The Sizewell C Project

5.5 Two Village Bypass Flood Risk Assessment Addendum Appendices A-D

APPENDIX B: COLLATED COMMENTS FROM THE ENVIRONMENT AGENCY RECEIVED ON 5TH FEBRUARY 2020 AND 4TH AUGUST 2020

Plate 3.2: Difference in maximum flood depth – baseline 1 in 100-year event with 25% climate change allowance for 2030 tidal boundary uplift

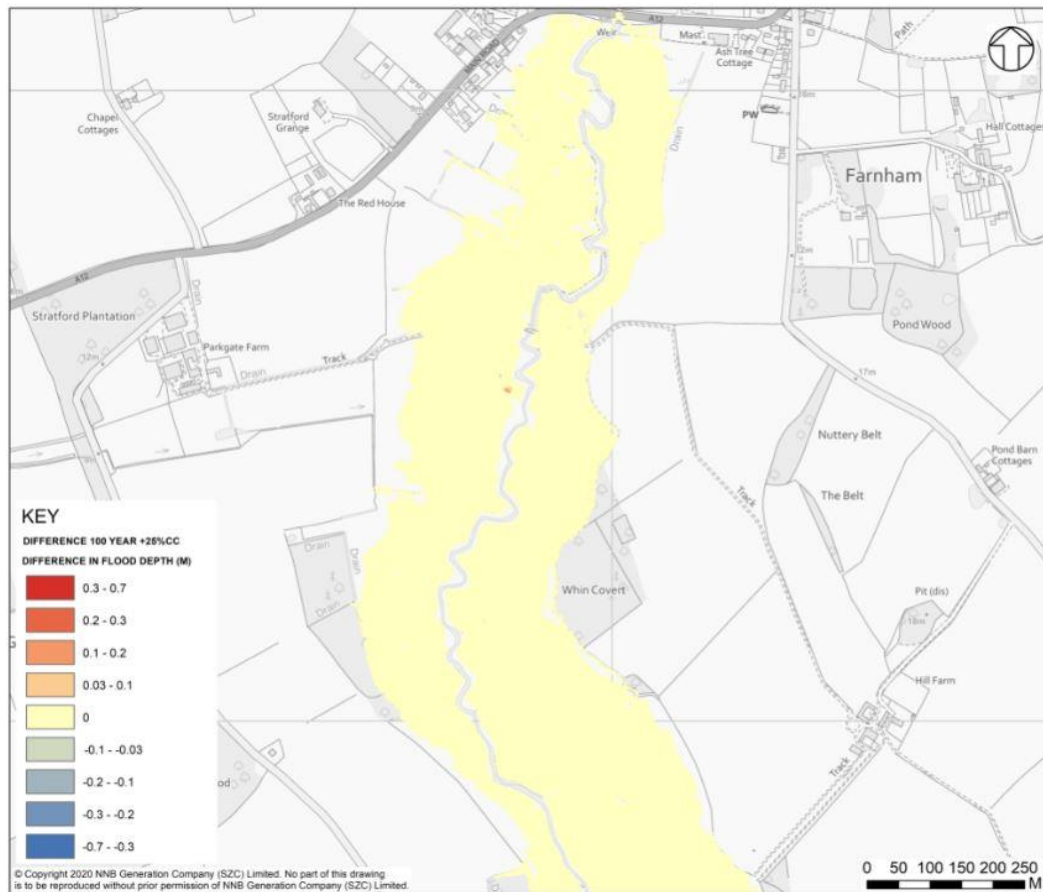
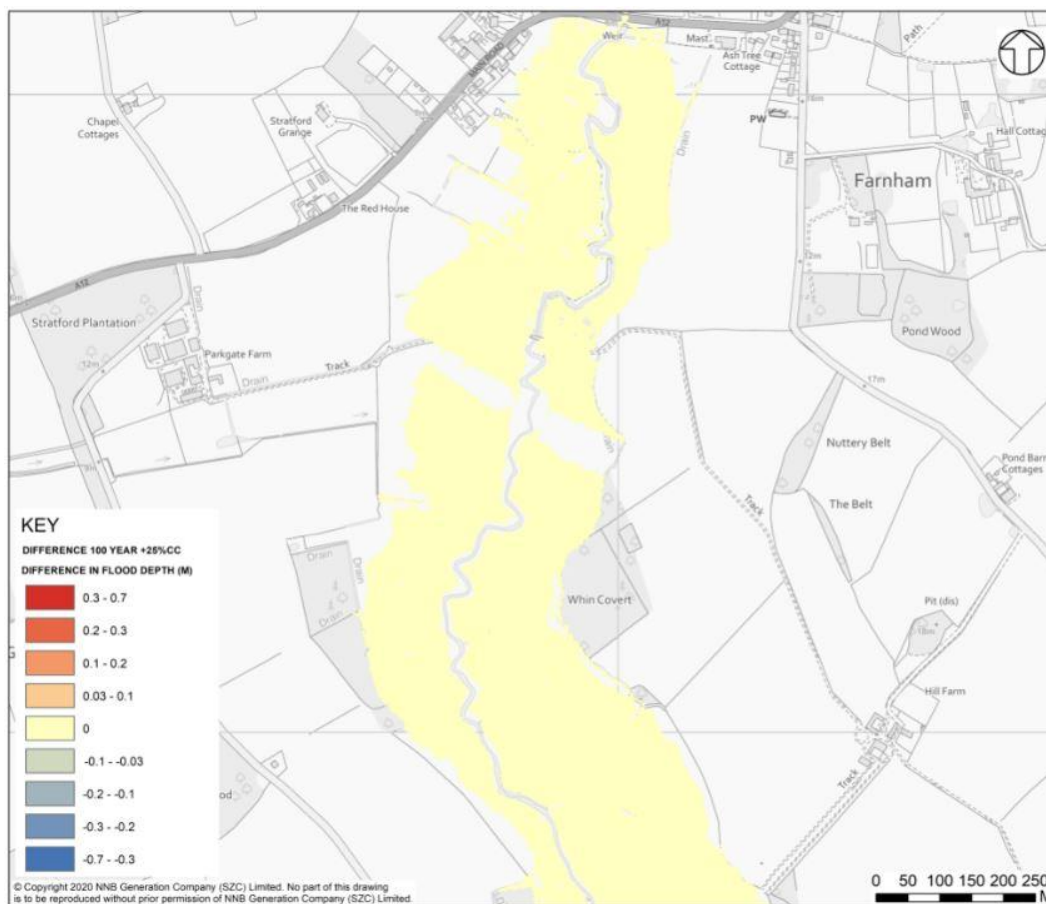
3.2.1 The Environment Agency Comments (comment 2.6 in **Appendix B** in the **Two Village Bypass FRA Addendum**, Doc Ref. 5.5) state that:

3.2.5 Given that the revised uplifts were higher than previously applied (+0.33m to both return period runs), both the baseline and with scheme scenarios were run to assess the impact of the proposed development on changes to the flood risk in the surrounding areas.

3.2.6 **Plate 3.2** shows that for the baseline 1 in 100-year with 25% climate change scenario and the 2030 tidal boundary uplift, maximum flood depths have not changed in the floodplain surrounding the development. **Plate 3.3** shows the same trend for the with scheme run of the same scenario.

Plate 3.6: Difference in maximum flood depth – baseline 1 in 100-year event with 35% climate change allowance for minus 20% roughness

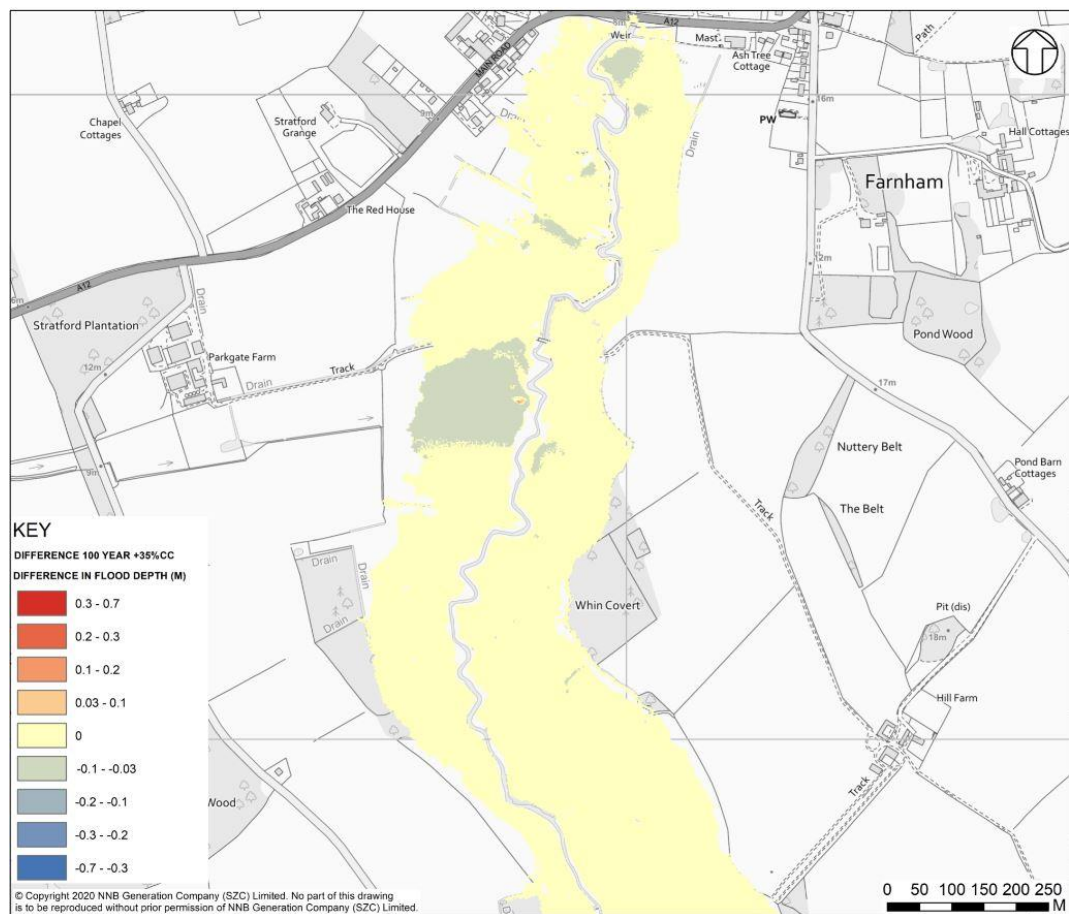
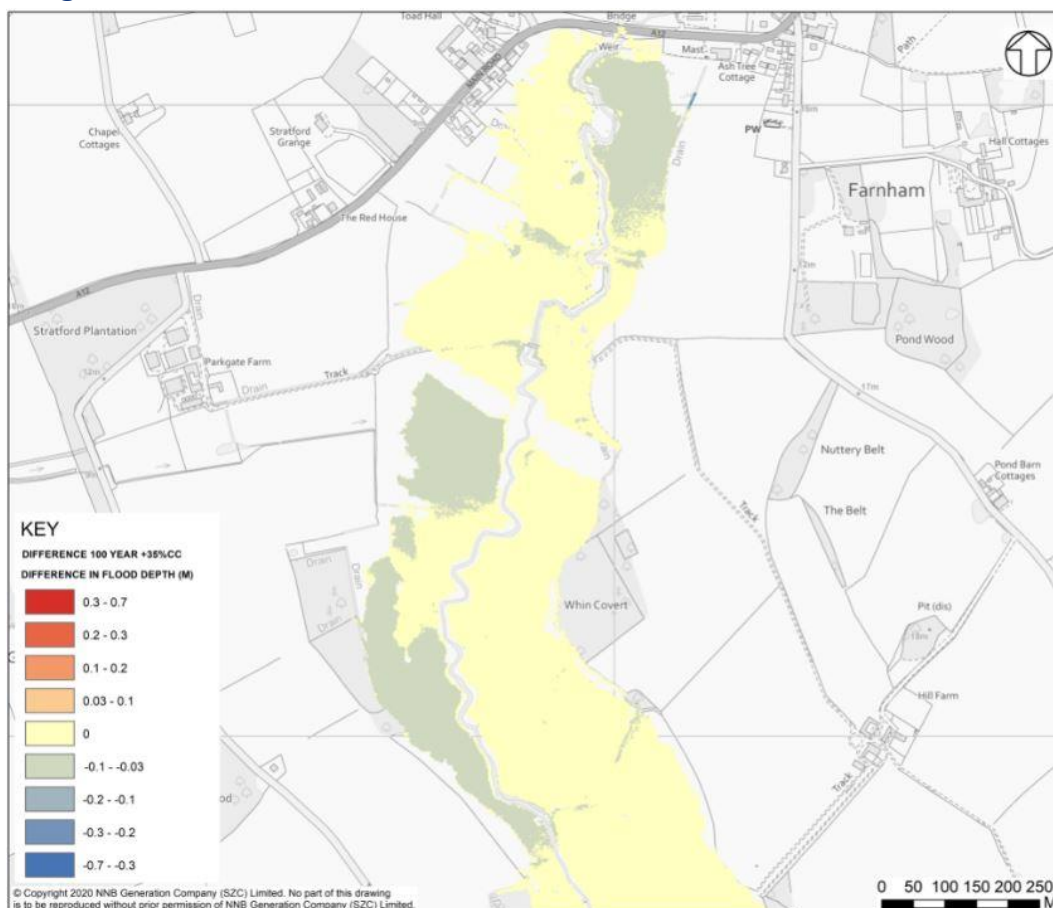
3.3.1 The Environment Agency Comments (comment 3.0 in **Appendix B** of the **Two Village Bypass FRA Addendum**, Doc Ref. 5.5) state that:

“It is recommended that sensitivity testing is undertaken on the parameters selected by the modeller to provide evidence on the effect of these assumptions on the potential conclusions ... Undertake sensitivity tests on manning's roughness values.”

3.3.6 **Plate 3.6** shows that for the baseline 1 in 100-year with 35% climate change allowance scenario with roughness decreased (minus) by 20%, there is an area on the western floodplain where food depths decreased between 0.03 – 0.1m. Elsewhere in the area of interest there is no change in maximum flood depths.

3.3.7 **Plate 3.7** shows the similar trend downstream of the proposed road embankment for the with scheme scenario and small area further upstream of the development, where there are also areas with slightly reduced maximum flood depth and no change in flood depths in other areas around the proposed development.

Plate 3.14: Difference in maximum flood depth – baseline 1 in 100-year event with 35% climate change allowance for change in Manning's n value

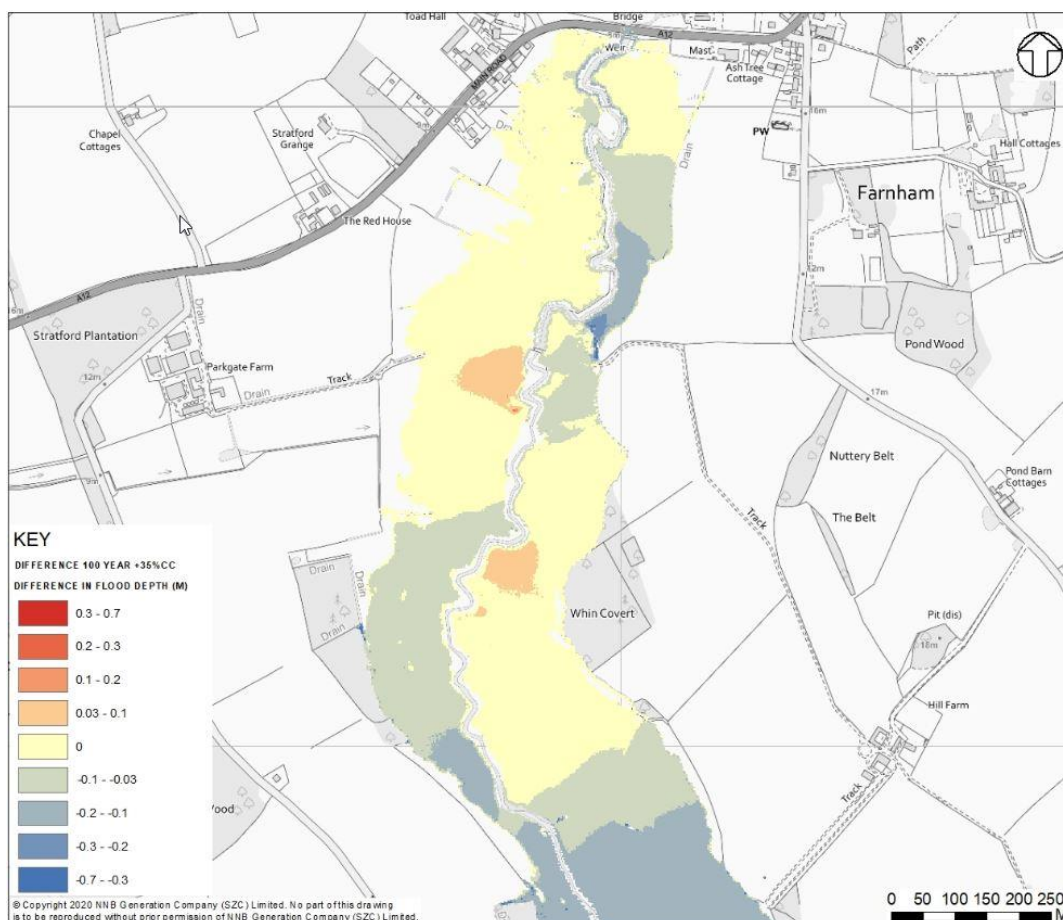
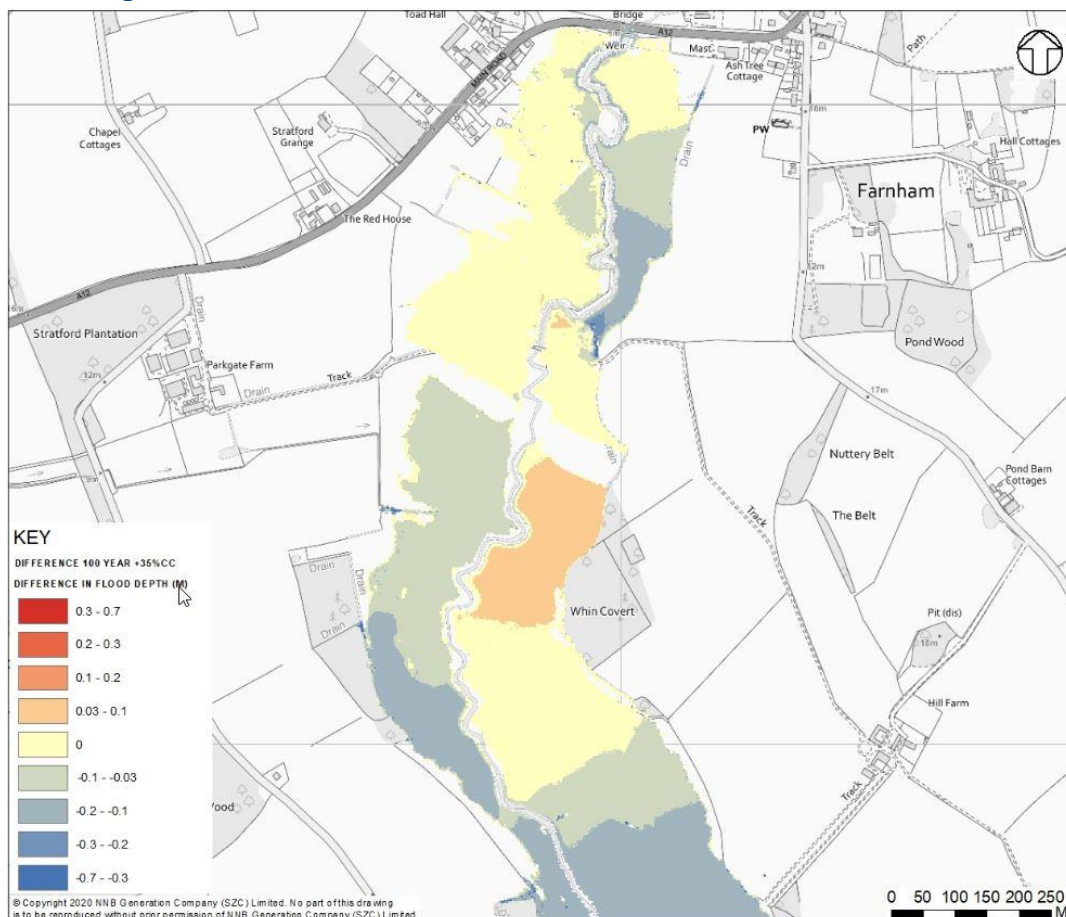
2.8	2VB Hydraulic Model	n/a	Stability patch roughness value very high	2D roughness values generally appear sensible, with the exception of a stability patch of 0.85 applied along all banks throughout model. This value is very high and requires further justification as to its use. .tmf states that it is for grassed banks, but the "patch value" is much higher than the standard value for grass (is closer to a value used for solid buildings).	Provide justification or amend Mannings's n values for stability patch	2	05/02/2020	Sensitivity test has been carried out within the modelling. The results of this have been presented in the FRA Addendum and accompanying Modelling Report Addendum.
3	2VB Hydraulic Model	n/a	Sensitivity testing	No indication of sensitivity testing other than on pier width and referring to sensitivity testing undertaken in the 2012 study. It is recommended that sensitivity testing is undertaken on the parameters selected by the modeller to provide evidence on the effect of these assumptions on the potential conclusions.	Undertake sensitivity tests on manning's roughness values and DS boundary conditions	2	05/02/2020	Sensitivity test has been carried out within the modelling. The results have been presented in the FRA Addendum and accompanying Modelling Report Addendum.

3.4.1 The Environment Agency Comments (comment 2.8 in **Appendix B** of the **Two Village Bypass FRA Addendum**, Doc Ref. 5.5) state that:

3.4.4 To assess model sensitivity, the Manning’s n value at the stability patch was changed from 0.85 to 0.1. To control for variation, Manning’s n values for all other materials in the .tmf file remained unchanged. This test was simulated for the 1 in 100-year with 35% climate change scenario as higher events were too unstable when tested with lower roughness value in the stability patch.

3.4.5 **Plate 3.14** shows that for the baseline 1 in 100-year with 35% climate change scenario flood depths are lower in some areas (between -0.1m and -0.3m) mostly downstream of the area of interest and small area on the eastern floodplain upstream of the proposed development. There two small areas with increased max flood depth (up to +0.1m), one upstream of the proposed development on the western floodplain, and the other further downstream.

3.4.6 **Plate 3.15** shows the with scheme 1 in 100-year with 35% climate change scenario where flood depths are also slightly lower, mostly in the downstream area of the model, closer to where the stability patch has a direct impact. Immediately downstream of the proposed development on the western floodplain flood depth decrease (up to -0.1m) and on the eastern floodplain the flood depth increase (up to +0.1m). There is also a

3.4.7 In summary, the stability patch seems to have greatest impact on the peak flood depth in the downstream area of the model, away from the area of interest, where the roughness value was amended. There is also some impact in the vicinity of the proposed development, however this comprises an increase or decrease in flood depth (up to 0.1m) in both the baseline and with scheme scenarios, suggesting that this is a relative change and the impact of the scheme would not change as a result of the higher roughness values.

Plate 3.16: Difference in maximum flood depth – baseline 1 in 100-year event with 35% climate change allowance with filled drains

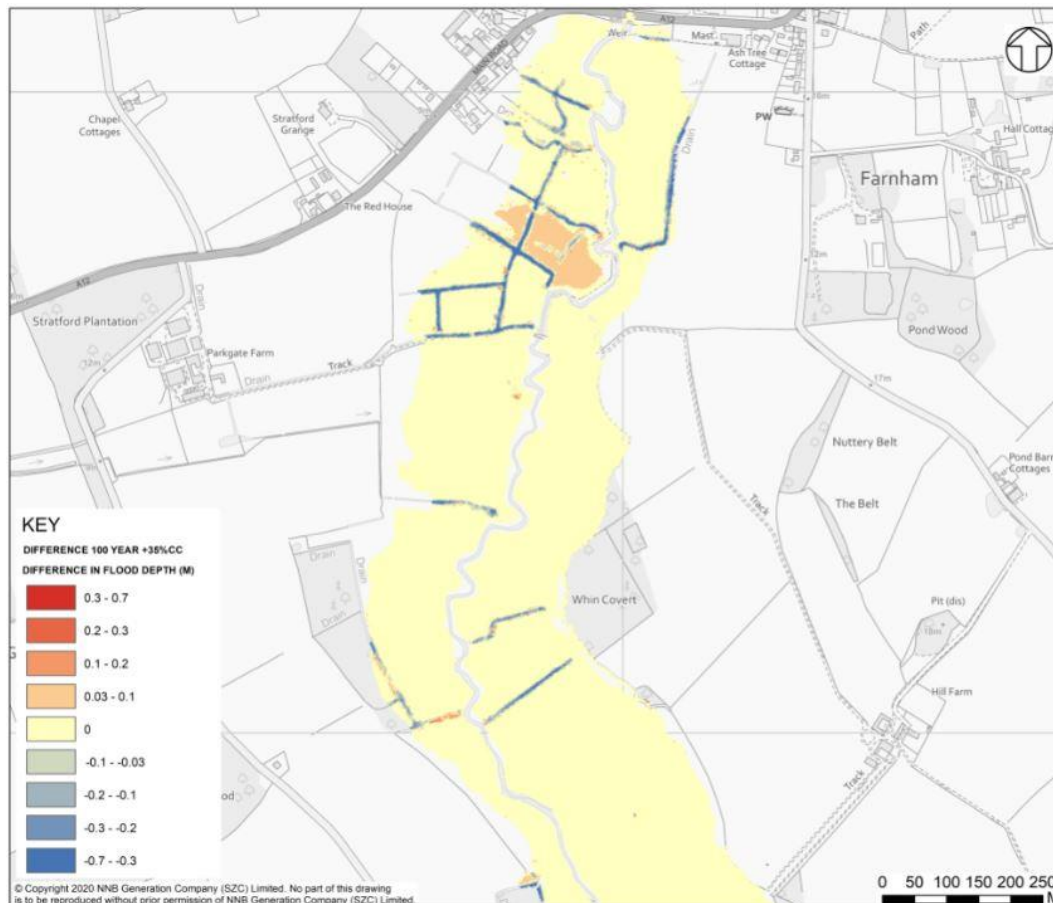
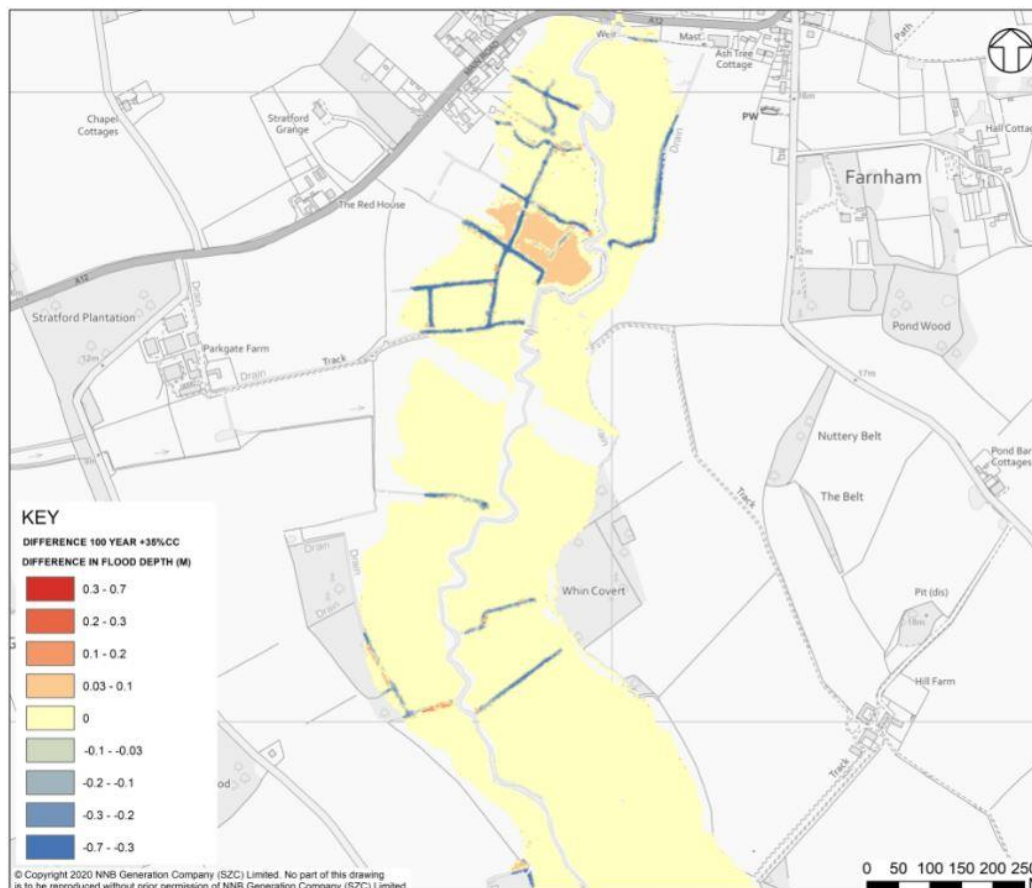
3.4	2VB Hydraulic Model	n/a	Z shape used to represent drains	The Z-shape 2d_zsh_fill_drains_004.mif, has been used to fill all drains in the 2012 model. This method has not been carried across to the extended 2D model domain.	Please provide justification as to why the z shape to fill drains (2d_zsh_fill_drains_004) has not been extended to cover the extended 2d domain (2d_bc_hxe_ALDE_005_2VB_001_R)	3	05/02/2020	Sensitivity test has been carried out within the modelling. The results have been presented in the FRA Addendum and accompanying Modelling Report Addendum.

3.5.1 The Environment Agency Comments (comment 3.4 in **Appendix B** of the **Two Village Bypass FRA Addendum**, Doc Ref. 5.5) state that:

- 3.5.3 This approach was adopted for the Application in the extended 2D model domain between the A12 at Farnham and the railway line to the south.
- 3.5.4 Following the Environment Agency's comments, to assess sensitivity of the model response to 'filled' drains, the same methodology was applied to raise the bed level of the drains within the extended 2D model domain (2d_bc_hxe_ALDE_005_2VB_001_R) north of the railway line.

- 3.5.5 **Plate 3.16** for the baseline 100-year with 35% climate change scenario shows that, other than expected decrease in flood depths within the filled drains, the overall flood depths within the floodplain have not changed significantly. **Plate 3.17** shows an identical pattern for the with scheme 100-year with 35% climate change scenario.

- 3.5.6 There is a small localised increase in flood extent on the western floodplain upstream of the development, associated with reduced storage capacity. Despite a small increase in flood extent to the north, this is far from any development and remains within the floodplain and is therefore not considered significant. 1D results show no difference in flow or stage.

Plate 3.18: Difference in with scheme maximum flood depth – 1 in 100-year event with 35% climate change allowance with blockage minus no blockage

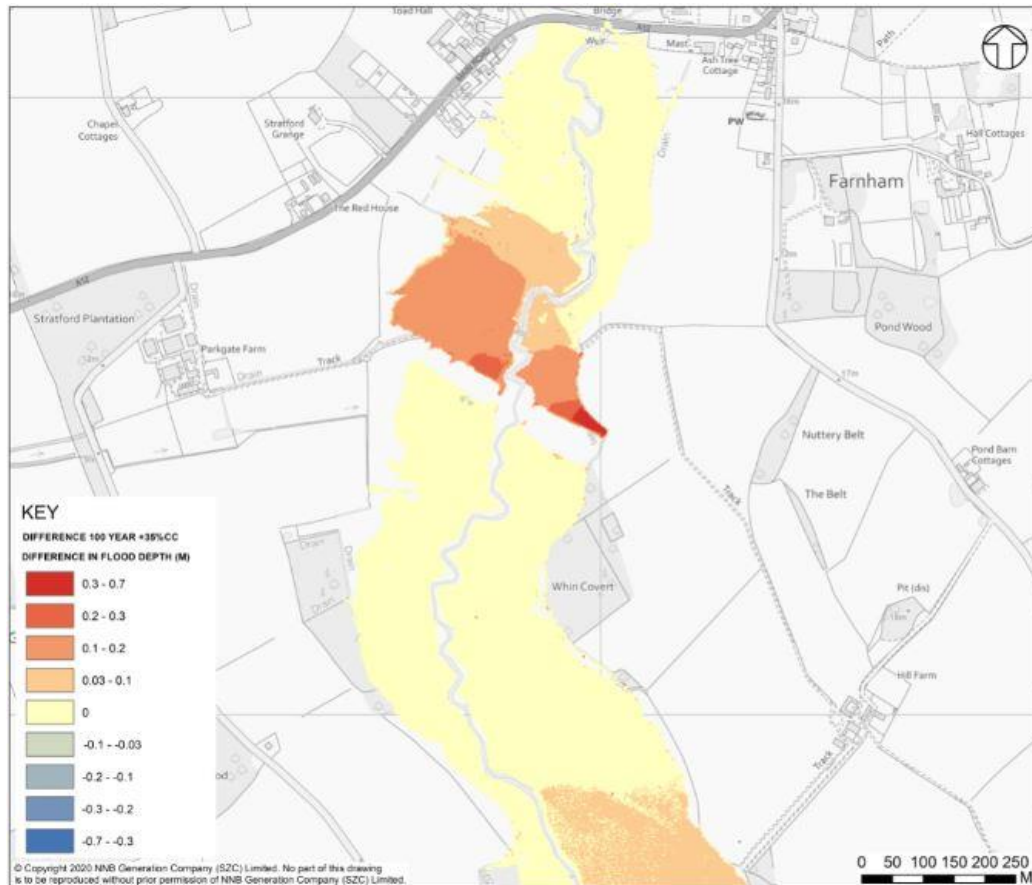
9.7	Two Village Bypass Flood Risk Assessment	8	Residual risk of blockage is not considered.	A common residual risk posed by bridge crossings and culverts is the possibility of it becoming blocked by debris. This has not be discussed within the FRA. It is appreciated that the bridge and culverts are large but the likelihood of this happening must be considered in the FRA.	Discuss likelihood of blockage of the bridge and culverts as a residual risk in the FRA.8.1.8 mentions blockages of culvert, but it doesn't appear as though any modelling been carried out to show what the impacts of a blockage may be.	2	05/02/2020	A blockage assessment had been carried out, post DCO submission, within the modelling. The results have been presented in the FRA Addendum and accompanying Modelling Report Addendum.

3.6.1 The Environment Agency Comments (comment 9.7 in **Appendix B** of the **Two Village Bypass FRA Addendum**, Doc Ref. 5.5) state that:

- 3.6.6 **Plate 3.18** shows that for the with scheme 100-year plus 35% climate change scenario, maximum flood depths increased as a result of the blockage by up to 0.45m on the eastern floodplain where a water backfilling effect extends up to 100m upstream of the development.

- 3.6.7 On the western floodplain this backfilling effect extends up to 200m with a maximum increase of 0.2m in flood depth immediately upstream of the embankment. Flood depths downstream of the development remained mostly unchanged, decreasing by 0.01 – 0.02m in places.

- 3.6.8 On the basis that the conservative approach to the blockage scenario results in limited localised change in the results of the modelling, it was not considered appropriate to carry out further testing of other climate change scenarios (i.e. 65% climate change scenario). This is supported by the results of the model runs for more extreme events i.e. 1,000-year scenario which show that maximum water levels are approximately 3m below the proposed bridge and road level.
